SUNDRY NOTICES AND REPORTS ON WELLS (DO NOT USE THIS FORM FOR PROPOSALS TO DRILL OR TO DEEPEN OR PLUG BACK TO A DIFFERENT RESERVOIR. USE "APPLICATION FOR PERMIT" (FORM C-101) FOR SUCH PROPOSALS.)		WELL API NO. 30-025-34767

2. Name of Operator Devon Energy Production Company, LP		6. State Oil & Gas Lease No.
3. Address of Operator 333 W. Sheridan Avenue, Oklahoma City, OK 73102		7. Lease Name or Unit Agreement Name THISTLE UNIT

PROPOSED WELLBORE

**CONDITIONS OF APPROVAL
FOR PLUGGING AND ABANDONMENT
OCD - Southern District**

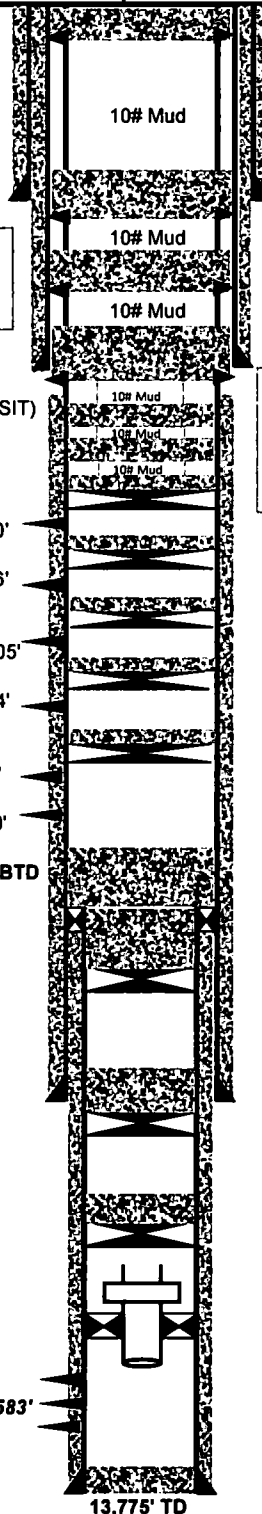
Proposed:
 1. Perf @ 1880'.
 2. Sqz 40 sx CI C from 1900'-1780'. WOC & tag.
 (T. Salt @ 1830')

Proposed:
 1. Perf @ 140'.
 2. Sqz CI C from 140' to surface.
 3. Cut WH off 3' BGL. Set dry hole marker.

Proposed:
 1. Perf @ 635'.
 2. Sqz 35 sx CI C from 635'-525'. WOC & tag.
 (Shoe @ 585')

Proposed:
 1. Perf @ 5270'.
 2. Sqz 95 sx CI C from 5270'-4900'. WOC & tag.
 (T. Delaware @ 5219'; Shoe @ 5053'; B. Salt @ 4950')

Proposed:
 1. Set CIBP @ 9450'. Tag. Circ 10# salt gel.
 2. Spot 25 sx CI H from 9450'-9330'.
 3. Spot 25 sx CI H from 9175'-9055'.
 4. Spot 25 sx CI C from 7450'-7300'.
 (Open perfs at @ 9500'; T. Bone Spring @ 9115'; Spacer @ 7450')
